VARIANCE REQUEST

Iowa Department of Natural Resources

SUBJECT: East Shore of Big Spirit Lake Relief Sewer
Spirit Lake, Iowa

PERMIT NO.: 93-132-S

JONES PASTURE LS 4-4

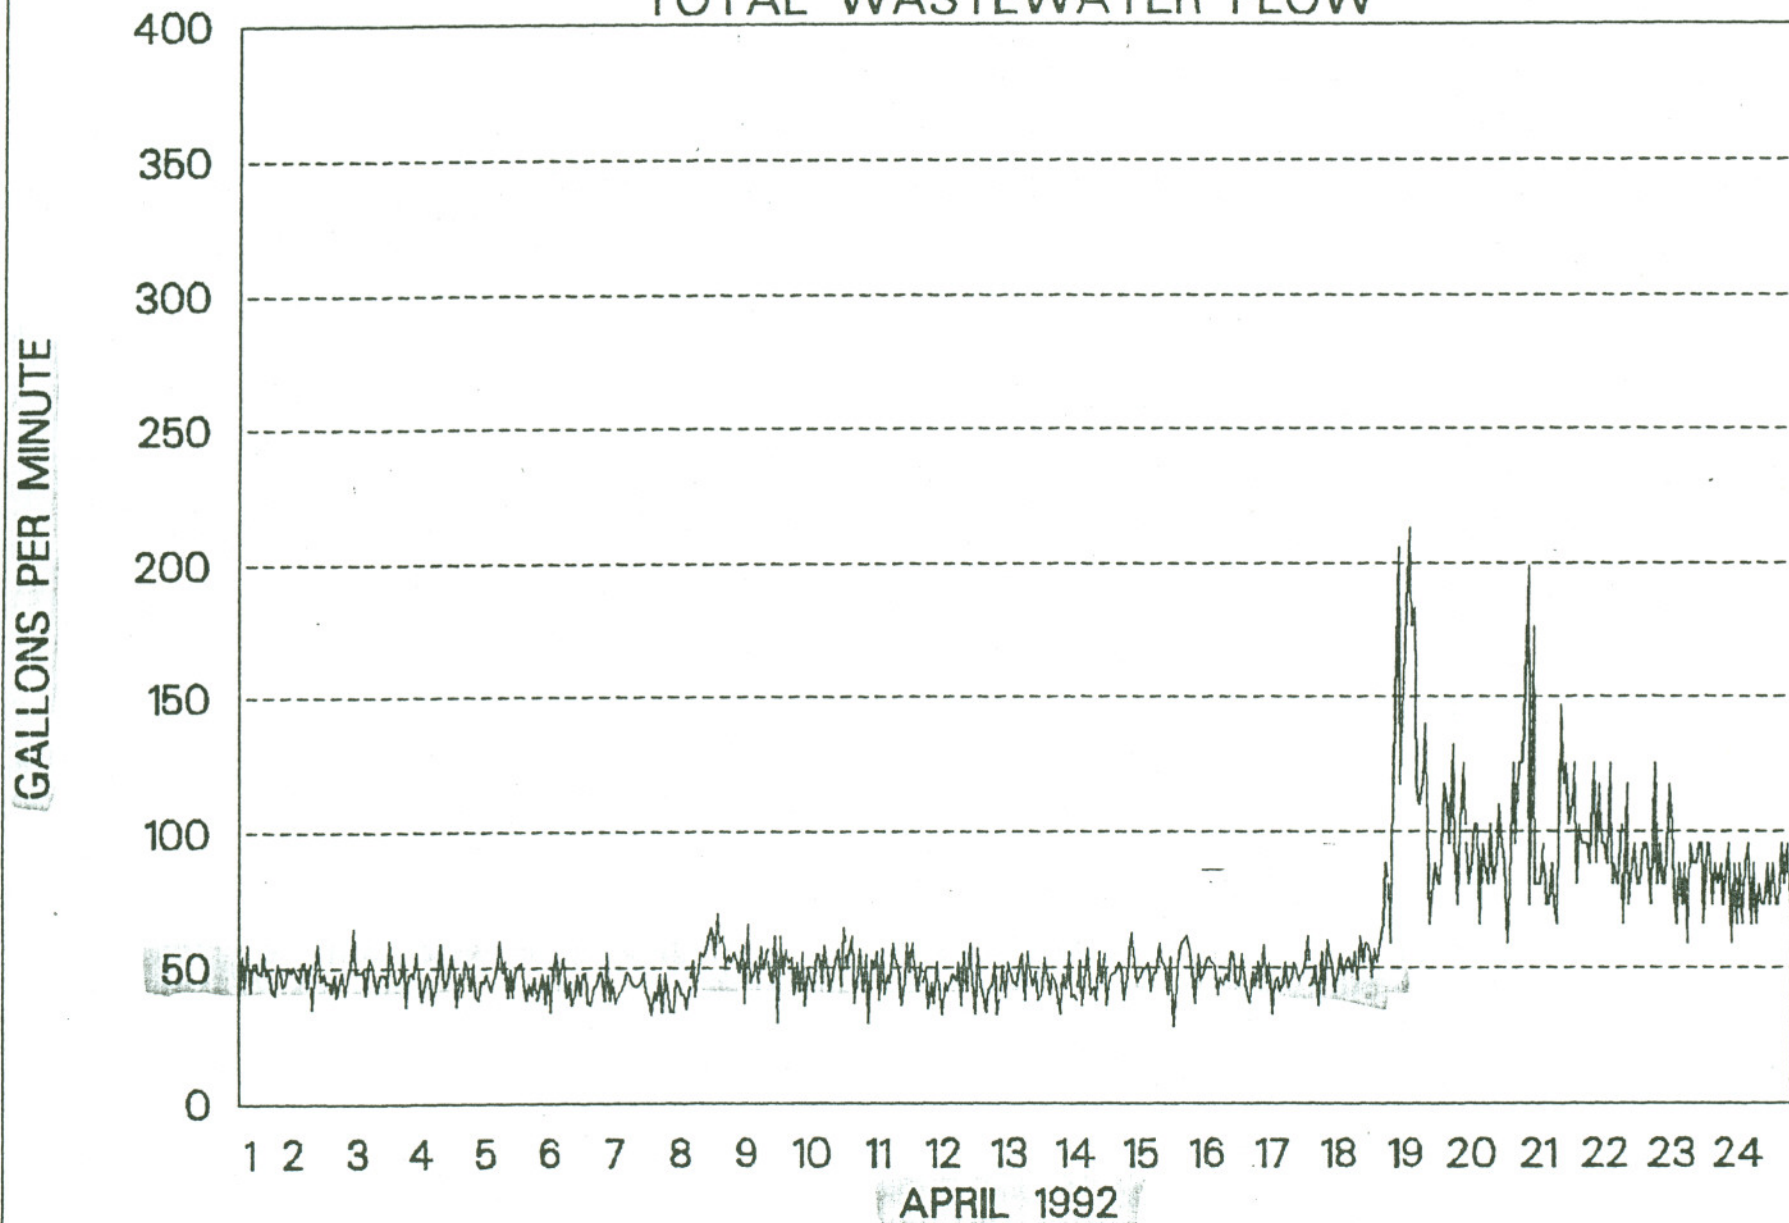
Check detention in force main during off-season usage. From flow measurements for the area served by the lift station for April 1992 it is noted that the ADW flow approximates 50 gpm

Force main - 14,922' of 8" D.I.P.

$$\text{Area 8" sewer} = 0.3491 \text{ ft}^2$$

Capacity of sewer line

$$Q = 0.3491 \times 14,922 = \underline{5,209.3 \text{ ft}^3} = \underline{38,965}$$

$$\text{ADW flow} = 50 \text{ gpm} = \underline{72,000 \text{ GPD}}$$

Detention time

$$\frac{38,965}{72,000} \times 24 \text{ hrs} \approx \underline{13 \text{ hrs.}}$$
